**Subject:** Transport Airplane Cabin Interiors  
Crashworthiness Handbook

**AC No:** 25-17A

**Change:** 1

2. **PRINCIPAL CHANGES.** Change 1 updates AC 25-17A, *Transport Airplane Cabin Interiors Crashworthiness Handbook*, dated May 18, 2009. We have added the change number and date of revision at the top of each changed page. We have also marked the changes with a vertical change bar in the margin. Specifically, Change 1 incorporates the following changes:

FIGURE 81-2 HEAD STRIKE ZONE FOR § 25.785

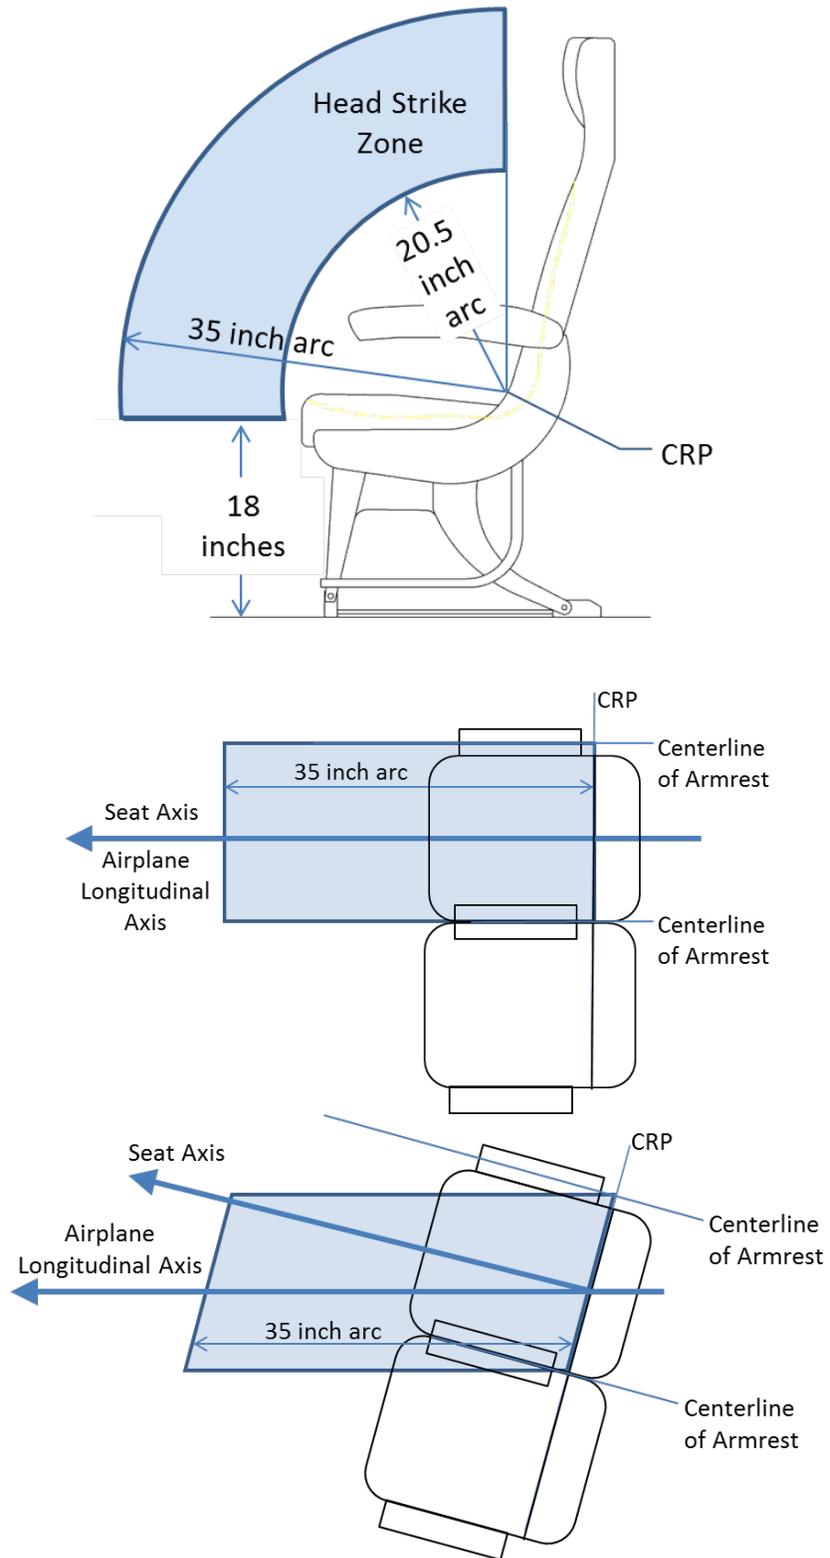
b. On pages 47, 60, 73, 86, 99, 113, 127 and 141, the figure showing the head strike zone is modified to show the zone is in the direction of the airplane longitudinal axis, and does not include those portions of the occupant's own seat that are very close to the seat back and seat bottom cushions.

(5) Paragraph (c)(2). The striking radius of the head for a forward facing seat (head strike zone) is considered to be a zone whose length is bounded between an arc at the shoulder height of the 5<sup>th</sup> percentile female occupant (20.5-inches) and an arc at the limit of the head path (35-inches) whose centers are at the intersection of the plane of the uncompressed top of the seat bottom cushion with the plane of the uncompressed front of the back cushion; commonly referred to as the cushion reference point (CRP), as shown in figure 81-2. Previously this was referred to as seat reference point (SRP). However, with the advent of dynamic seat testing, the definition for SRP was changed (refer to SAE ARP5526D). The head strike zone extends in the direction parallel to the airplane longitudinal axis. The width of the head strike zone is bounded by a vertical plane through the intersection of the centerlines of each armrest and the CRP as shown in figure 81-2. Typical installations to be considered are bulkheads, cabinets, tables, and passenger evacuation slide covers. The installation should not contain any pointed corners or sharp edges. The testing used to demonstrate that the installation is not injurious must take into account whether the system (e.g., seatback mounted telephone) is allowed to be used during taxi, takeoff and landing. If the system is allowed to be used during these phases of operation, the testing must consider the system in both the deployed and stowed position (e.g., seatback mounted telephone in or out of the cradle). If a surface or interior feature is located such that it is potentially hazardous in a combination of forward and side loads, it should be substantiated even if it might be slightly outside of the head strike zone. Any surface less than 18-inches above the floor need not be considered. Surfaces within the head strike zone may be padded with energy absorbing material, such as one inch of either Ensolite (Type AH, AHC, IV3, HHC or HH), Klegecell, or Airex 4070. Foam rubber is not satisfactory since it is an energy storing material. If the padding is easily removed, there should be acceptable placarding requiring the padding be in place during taxi, takeoff, and landing. (Amendment 25-0)

FIGURE 82-2 HEAD STRIKE ZONE FOR § 25.785

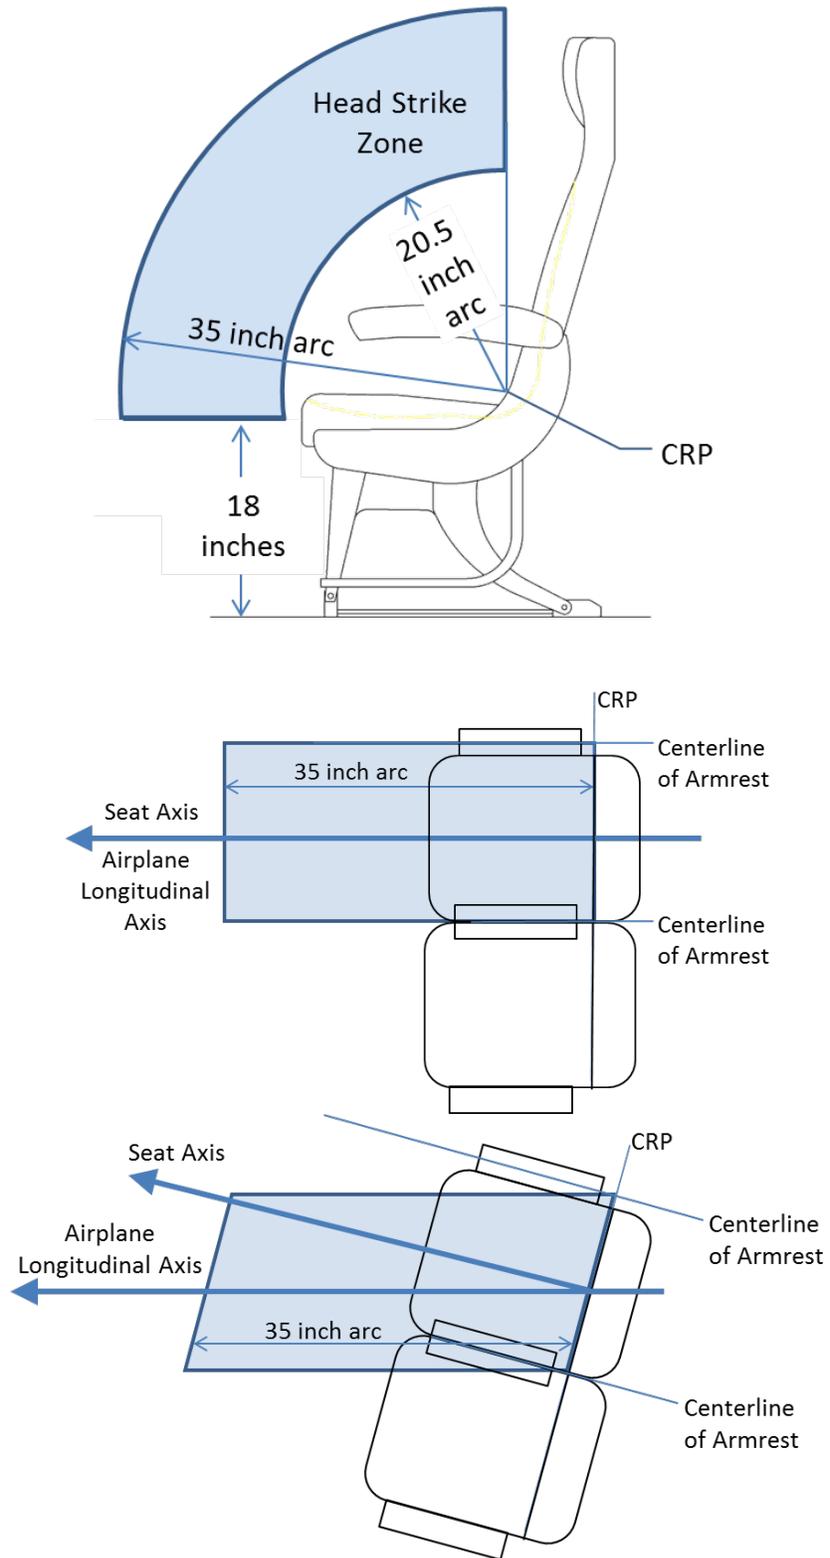
(5) Paragraph (c)(2). The striking radius of the head for a forward facing seat (head strike zone) is considered to be a zone whose length is bounded between an arc at the shoulder height of the 5th percentile female occupant (20.5-inches) and an arc at the limit of the head path (35-inches) whose centers are at the intersection of the plane of the uncompressed top of the seat bottom cushion with the plane of the uncompressed front of the back cushion; commonly referred to as the cushion reference point (CRP), as shown in figure 82-2. Previously this was referred to as seat reference point (SRP). However, with the advent of dynamic seat testing, the definition for SRP was changed (refer to SAE ARP5526D). The head strike zone extends in the direction parallel to the airplane longitudinal axis. The width of the head strike zone is bounded by a vertical plane through the intersection of the centerlines of each armrest and the CRP as shown in figure 82-2. Typical installations to be considered are bulkheads, cabinets, tables, and passenger evacuation slide covers. The installation should not contain any pointed corners or sharp edges. The testing used to demonstrate that the installation is not injurious must take into account whether the system (e.g., seatback mounted telephone) is allowed to be used during taxi, takeoff and landing. If the system is allowed to be used during these phases of operation, the testing must consider the system in both the deployed and stowed position (e.g., seatback mounted telephone in or out of the cradle). If a surface or interior feature is located such that it is potentially hazardous in a combination of forward and side loads, it should be substantiated even if it might be slightly outside of the head strike zone. Any surface less than 18-inches above the floor need not be considered. Surfaces within the head strike zone may be padded with energy absorbing material, such as one inch of either Ensolite (Type AH, AHC, IV3, HHC or HH), Klegecell, or Airex 4070. Foam rubber is not satisfactory since it is an energy storing material. If the padding is easily removed, there should be acceptable placarding requiring the padding be in place during taxi, takeoff, and landing. (Amendment 25-0)

FIGURE 83-2 HEAD STRIKE ZONE FOR § 25.785

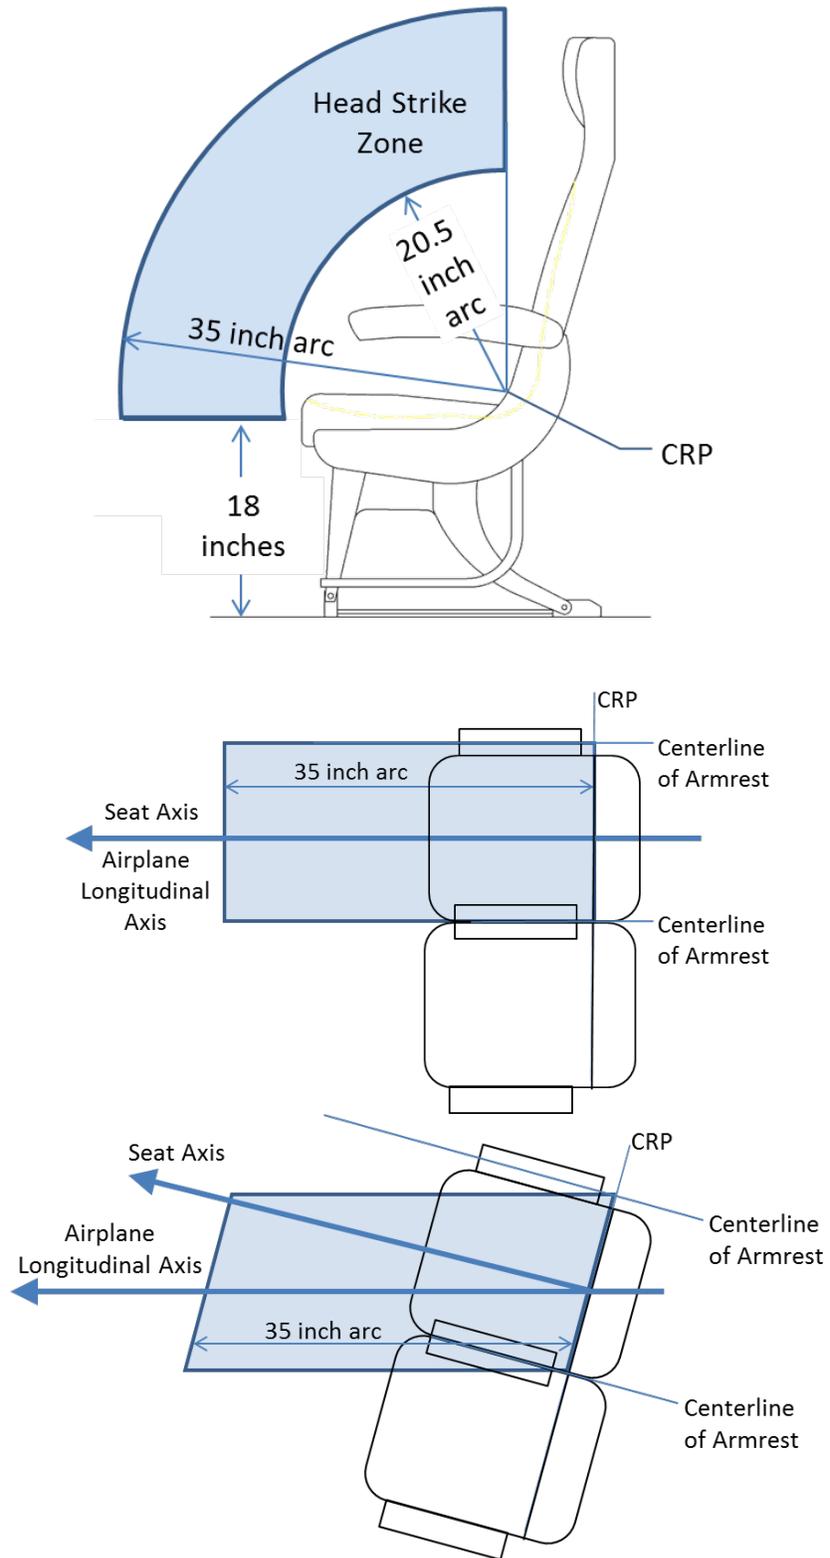
(6) Paragraph (c)(2). The striking radius of the head for a forward facing seat (head strike zone) is considered to be a zone whose length is bounded between an arc at the shoulder height of the 5<sup>th</sup> percentile female occupant (20.5-inches) and an arc at the limit of the head path (35-inches) whose centers are at the intersection of the plane of the uncompressed top of the seat bottom cushion with the plane of the uncompressed front of the back cushion; commonly referred to as the cushion reference point (CRP), as shown in figure 83-2. Previously this was referred to as seat reference point (SRP). However, with the advent of dynamic seat testing the definition for SRP was changed (refer to SAE ARP6626D). The head strike zone extends in the direction parallel to the airplane longitudinal axis. The width of the head strike zone is bounded by a vertical plane through the intersection of the centerlines of each armrest and the CRP as shown in figure 83-2. Typical installations to be considered are bulkheads, cabinets, tables, and passenger evacuation slide covers. The installation should not contain any pointed corners or sharp edges. The testing used to demonstrate that the installation is not injurious must take into account whether the system (e.g., seatback mounted telephone) is allowed to be used during taxi, takeoff and landing. If the system is allowed to be used during these phases of operation, the testing must consider the system in both the deployed and stowed position (e.g., seatback mounted telephone in or out of the cradle). If a surface or interior feature is located such that it is potentially hazardous in a combination of forward and side loads, it should be substantiated even if it might be slightly outside of the head strike zone. Any surface less than 18-inches above the floor need not be considered. Surfaces within the head strike zone may be padded with energy absorbing material, such as one inch of either Ensolite (Type AH, AHC, IV3, HHC or HH), Klegecell, or Airex 4070. Foam rubber is not satisfactory since it is an energy storing material. If the padding is easily removed, there should be acceptable placarding requiring the padding be in place during taxi, takeoff, and landing. (Amendment 25-0)

FIGURE 84-2 HEAD STRIKE ZONE FOR § 25.785

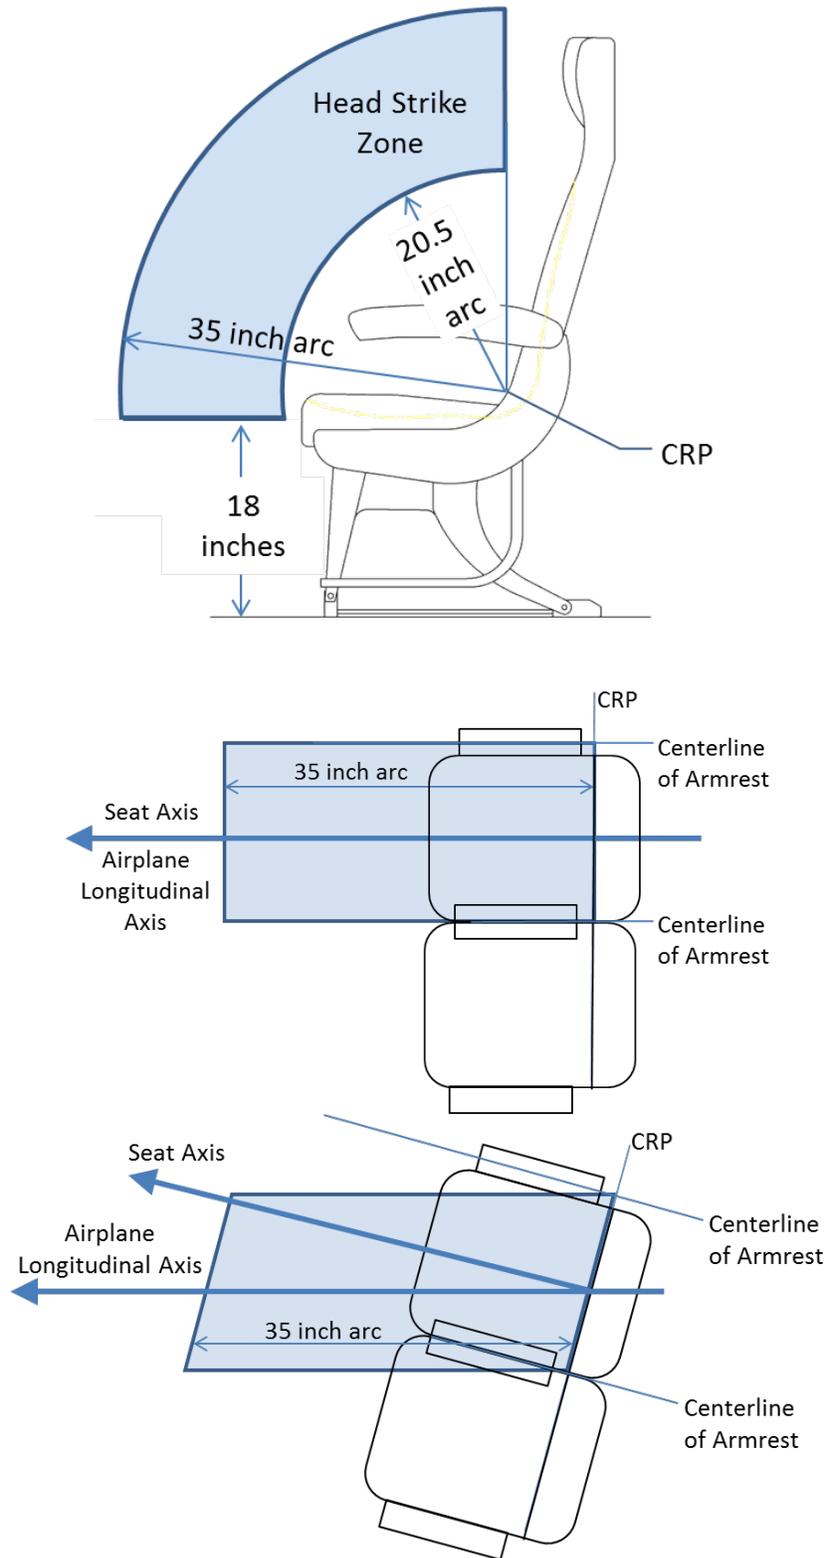
(6) Paragraph (c)(2). The striking radius of the head for a forward facing seat (head strike zone) is considered to be a zone whose length is bounded between an arc at the shoulder height of the 5<sup>th</sup> percentile female occupant (20.5-inches) and an arc at the limit of the head path (35-inches) whose centers are at the intersection of the plane of the uncompressed top of the seat bottom cushion with the plane of the uncompressed front of the back cushion; commonly referred to as the cushion reference point (CRP), as shown in figure 84-2. Previously this was referred to as seat reference point (SRP). However, with the advent of dynamic seat testing the definition for SRP was changed (refer to SAE ARP5526D). The head strike zone extends in the direction parallel to the airplane longitudinal axis. The width of the head strike zone is bounded by a vertical plane through the intersection of the centerlines of each armrest and the CRP as shown in figure 84-2. Typical installations to be considered are bulkheads, cabinets, tables, and passenger evacuation slide covers. The installation should not contain any pointed corners or sharp edges. The testing used to demonstrate that the installation is not injurious must take into account whether the system (e.g., seatback mounted telephone) is allowed to be used during taxi, takeoff and landing. If the system is allowed to be used during these phases of operation, the testing must consider the system in both the deployed and stowed position (e.g., seatback mounted telephone in or out of the cradle). If a surface or interior feature is located such that it is potentially hazardous in a combination of forward and side loads, it should be substantiated even if it might be slightly outside of the head strike zone. Any surface less than 18-inches above the floor need not be considered. Surfaces within the head strike zone may be padded with energy absorbing material, such as one inch of either Ensolite (Type AH, AHC, IV3, HHC or HH), Klegecell, or Airex 4070. Foam rubber is not satisfactory since it is an energy storing material. If the padding is easily removed, there should be acceptable placarding requiring the padding be in place during taxi, takeoff, and landing. (Amendment 25-0)

FIGURE 85-2 HEAD STRIKE ZONE FOR § 25.785

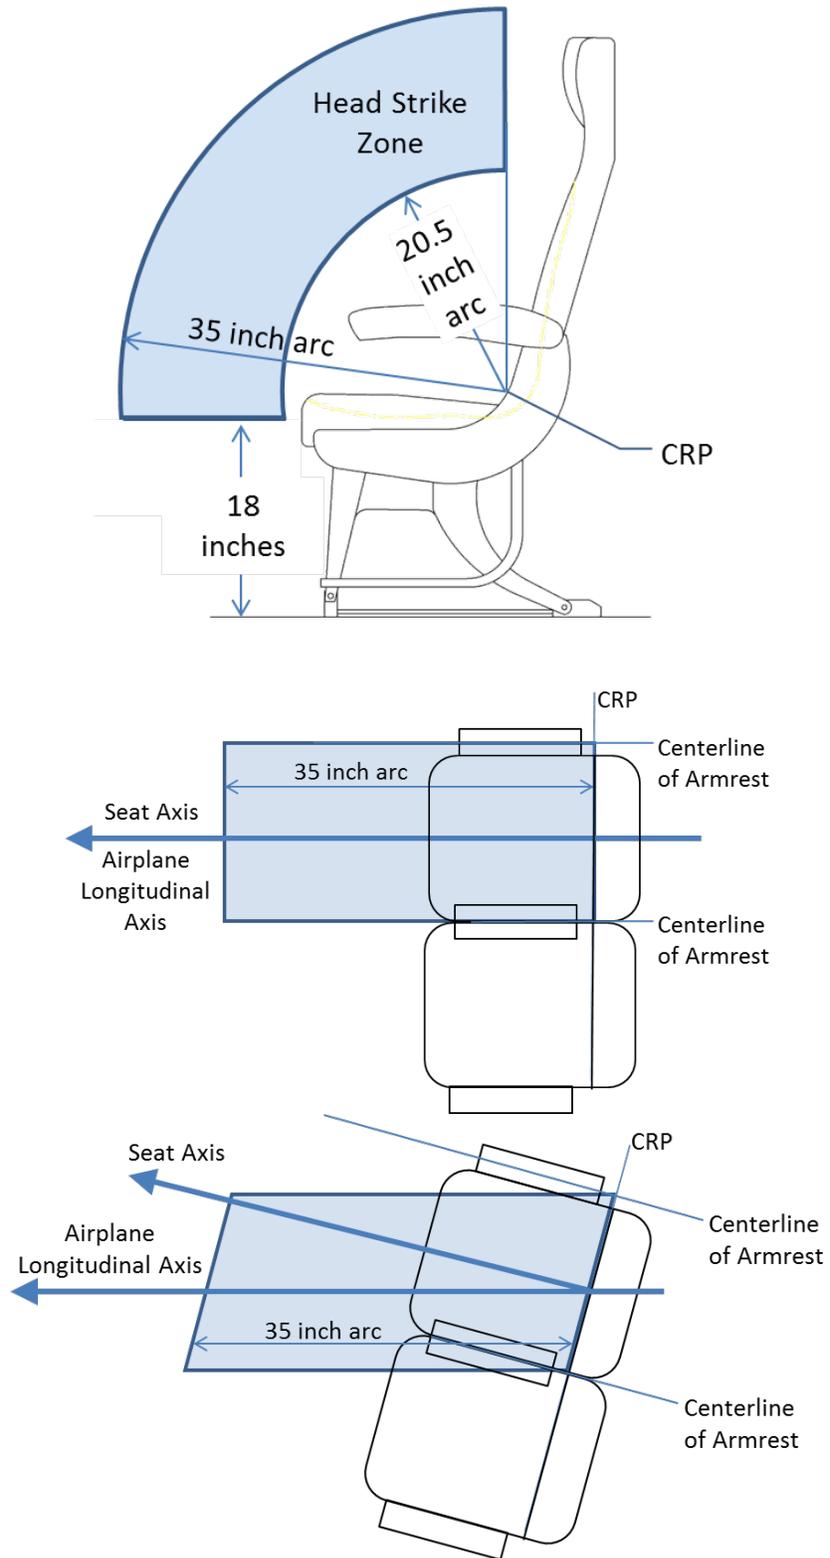
(6) Paragraph (c)(2). The striking radius of the head for a forward facing seat (head strike zone) is considered to be a zone whose length is bounded between an arc at the shoulder height of the 5<sup>th</sup> percentile female occupant (20.5-inches) and an arc at the limit of the head path (35-inches) whose centers are at the intersection of the plane of the uncompressed top of the seat bottom cushion with the plane of the uncompressed front of the back cushion; commonly referred to as the cushion reference point (CRP), as shown in figure 85-2. Previously this was referred to as seat reference point (SRP). However, with the advent of dynamic seat testing the definition for SRP was changed (refer to SAE ARP5526D). The head strike zone extends in the direction parallel to the airplane longitudinal axis. The width of the head strike zone is bounded by a vertical plane through the intersection of the centerlines of each armrest and the CRP as shown in figure 85-2. Typical installations to be considered are bulkheads, cabinets, tables, and passenger evacuation slide covers. The installation should not contain any pointed corners or sharp edges. The testing used to demonstrate that the installation is not injurious must take into account whether the system (e.g., seatback mounted telephone) is allowed to be used during taxi, takeoff and landing. If the system is allowed to be used during these phases of operation, the testing must consider the system in both the deployed and stowed position (e.g., seatback mounted telephone in or out of the cradle). If a surface or interior feature is located such that it is potentially hazardous in a combination of forward and side loads, it should be substantiated even if it might be slightly outside of the head strike zone. Any surface less than 18-inches above the floor need not be considered. Surfaces within the head strike zone may be padded with energy absorbing material, such as one inch of either Ensolite (Type AH, AHC, IV3, HHC or HH), Klegecell, or Airex 4070. Foam rubber is not satisfactory since it is an energy storing material. If the padding is easily removed, there should be acceptable placarding requiring the padding be in place during taxi, takeoff, and landing. (Amendment 25-0)
